**NOTICE OF ADDENDUM
ADDENDUM NO. 2**

**CONTRACT NO. 7939
MADISON MUNICIPAL BUILDING - RENOVATION**

This addendum is issued to modify, explain or correct the original Drawings, Specifications, or Contract Documents and is hereby made a part of the contract documents.

16 FRAMING DETAIL
1 1/2" = 1'-0"

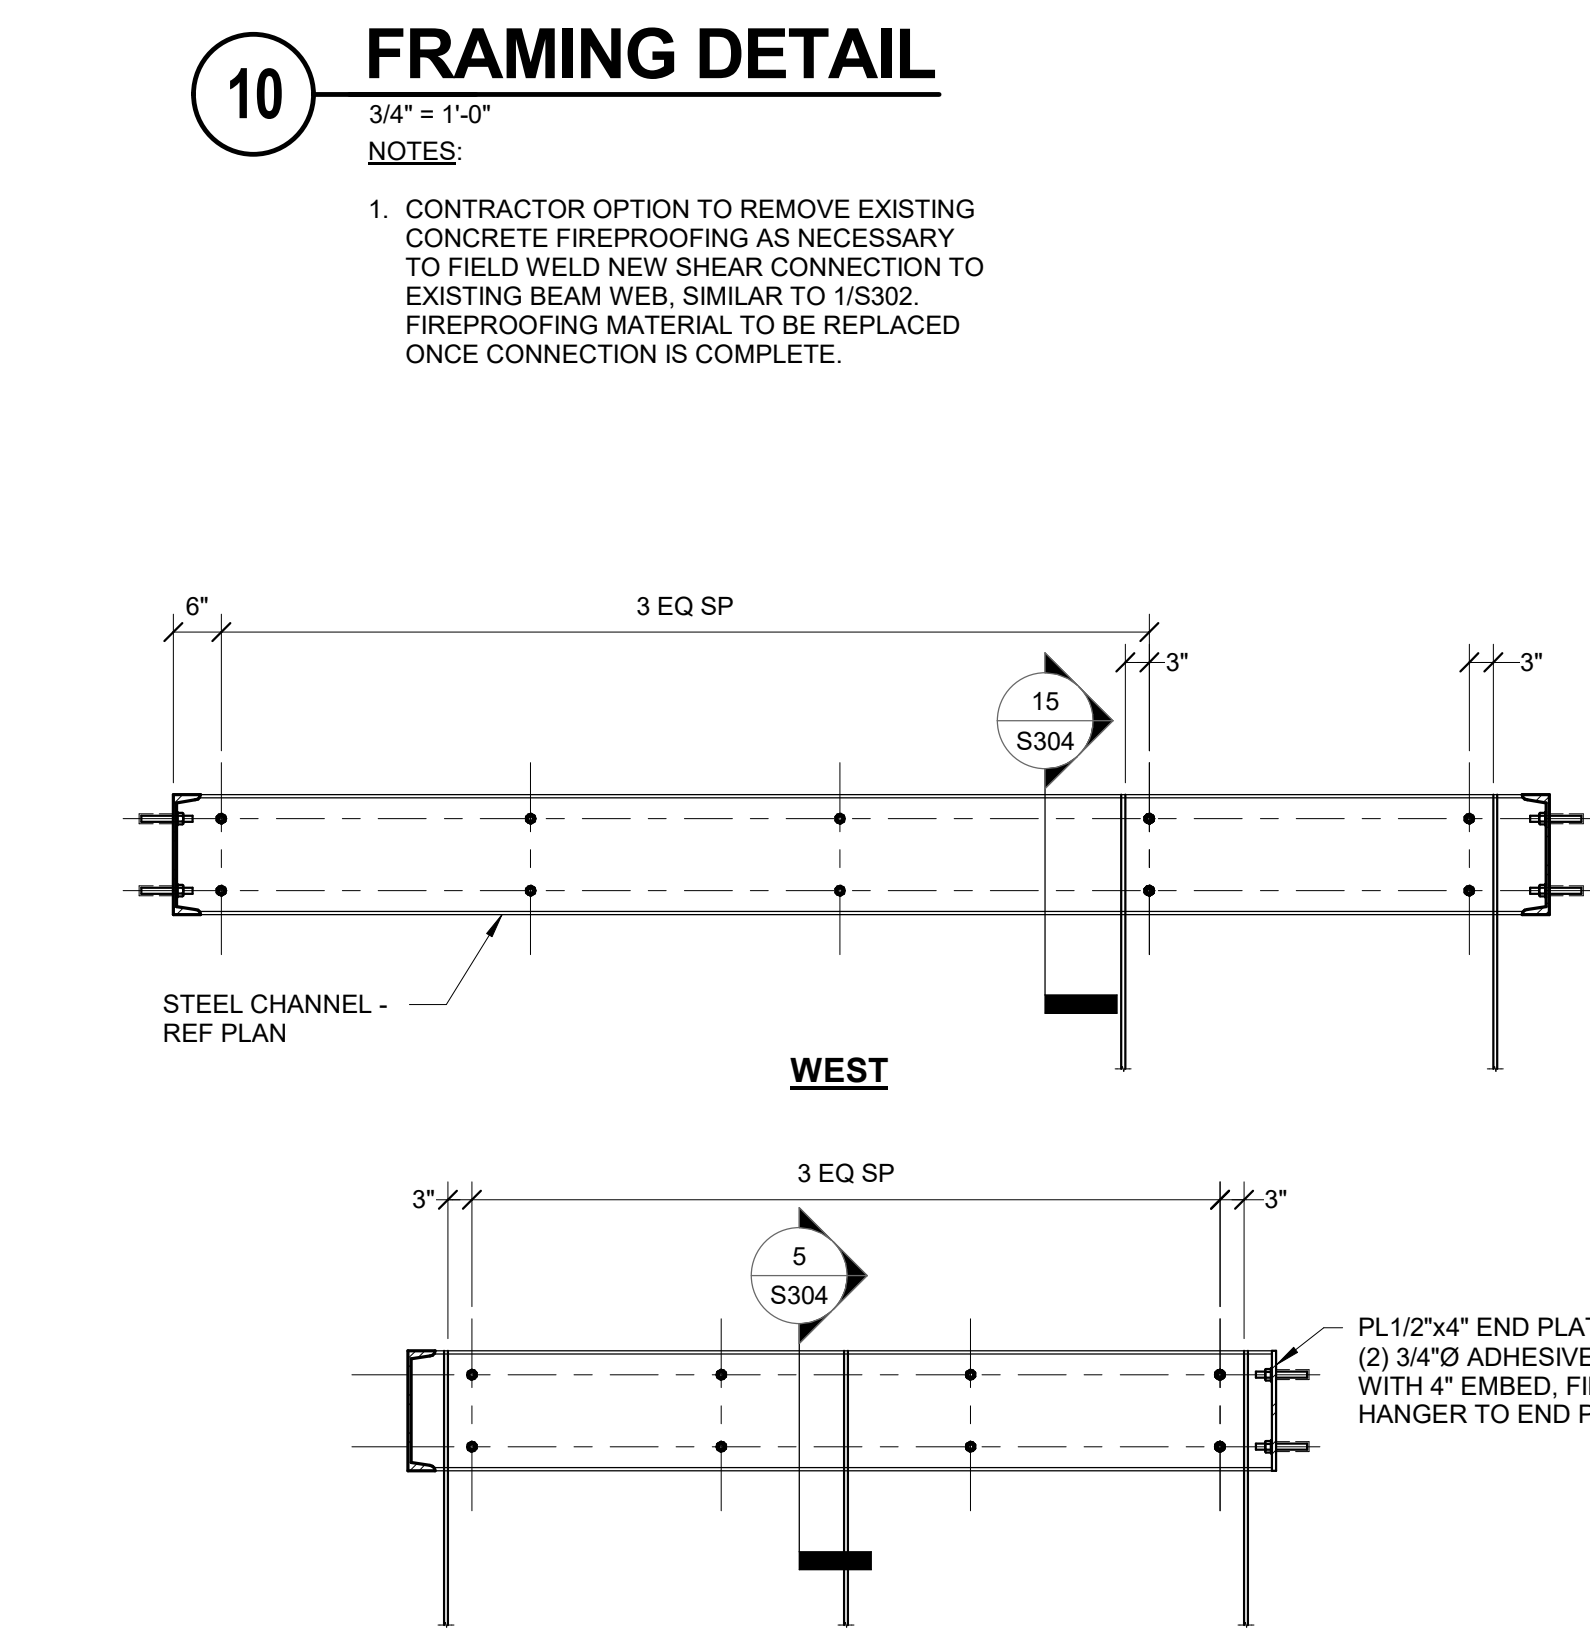
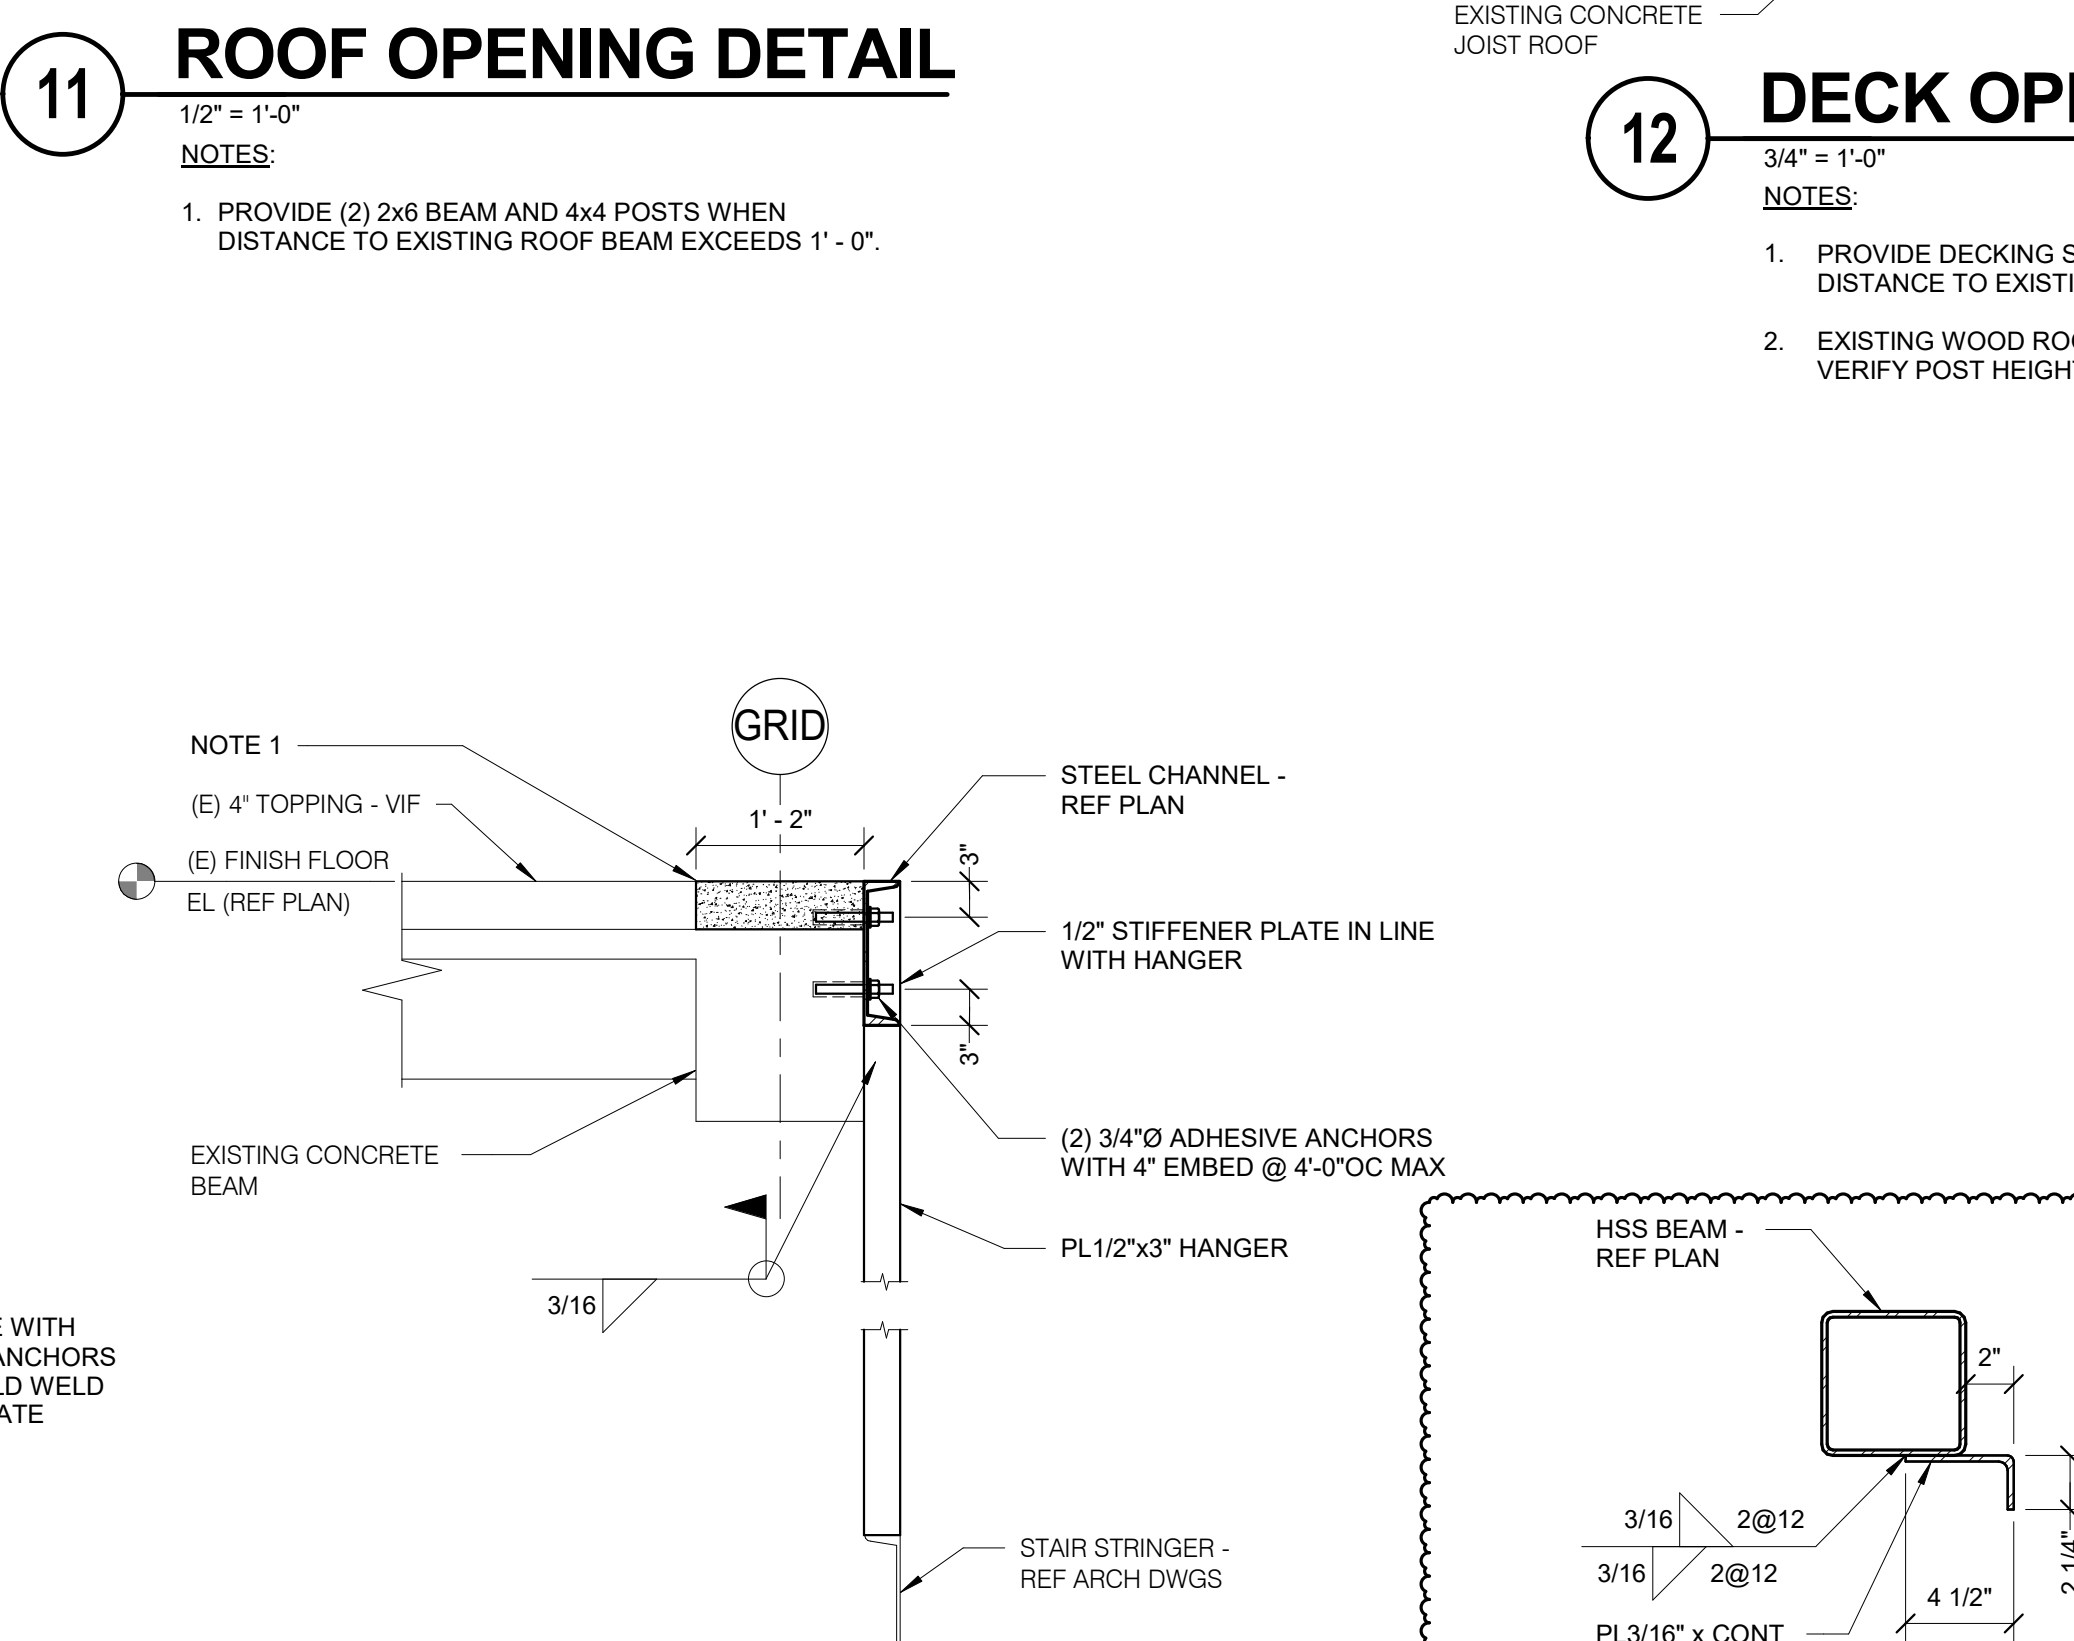
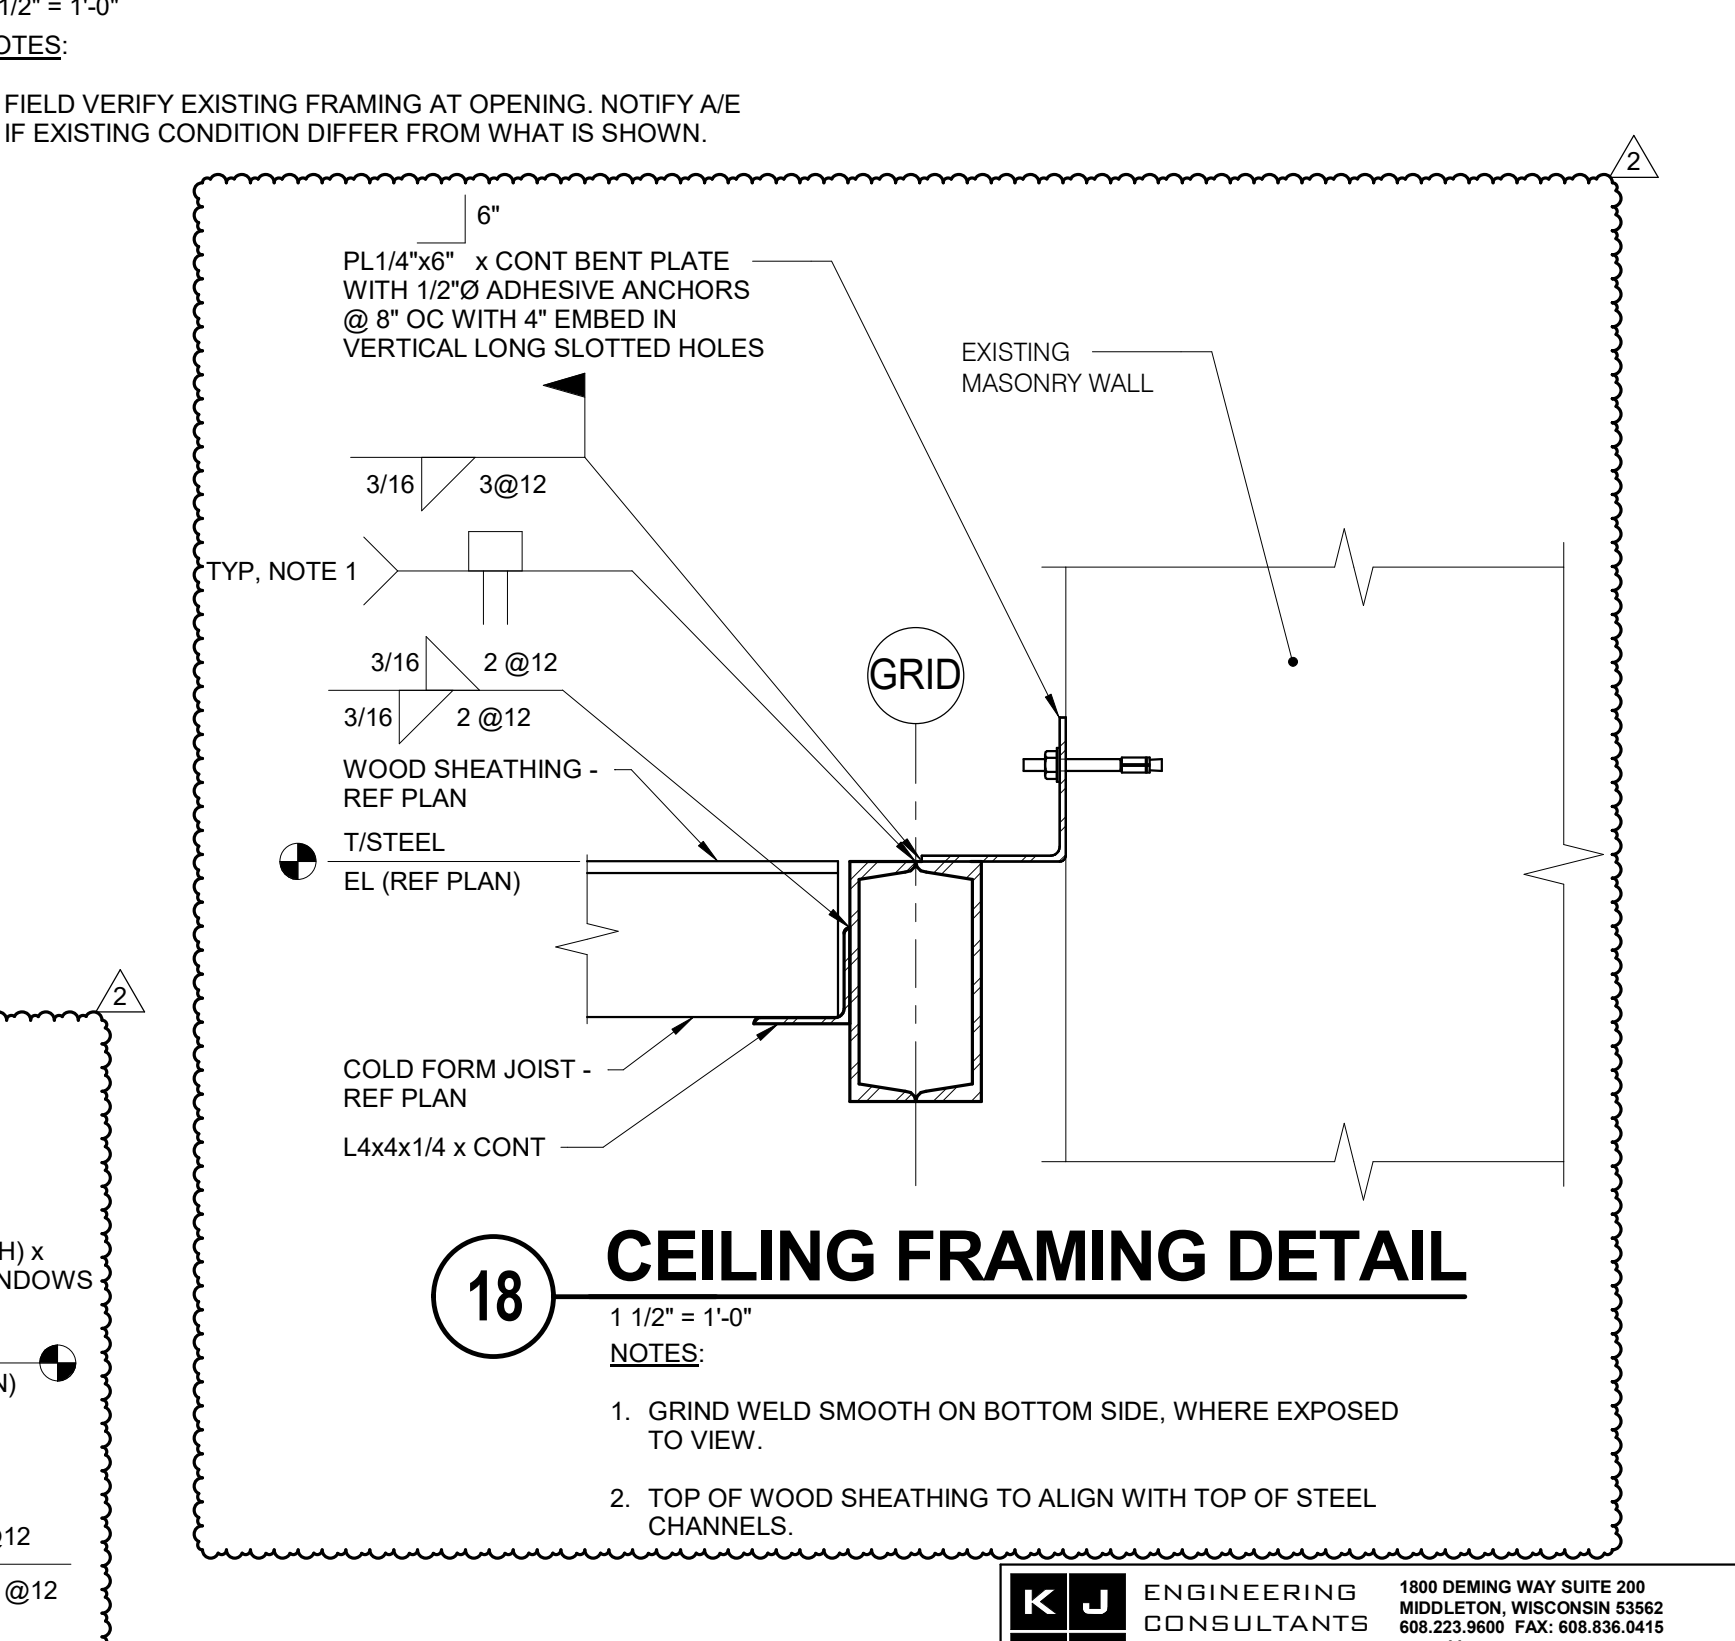
7. Drawing S302 – FRAMING DETAILS
 - a. **REVISE** details 9 and 12 per revised sheet S302.
8. Drawing S304 – FRAMING DETAILS
 - a. **REVISE** detail 7 per revised sheet S304.

- b. **ADD** details 16, 17 and 18 per revised sheet S304.
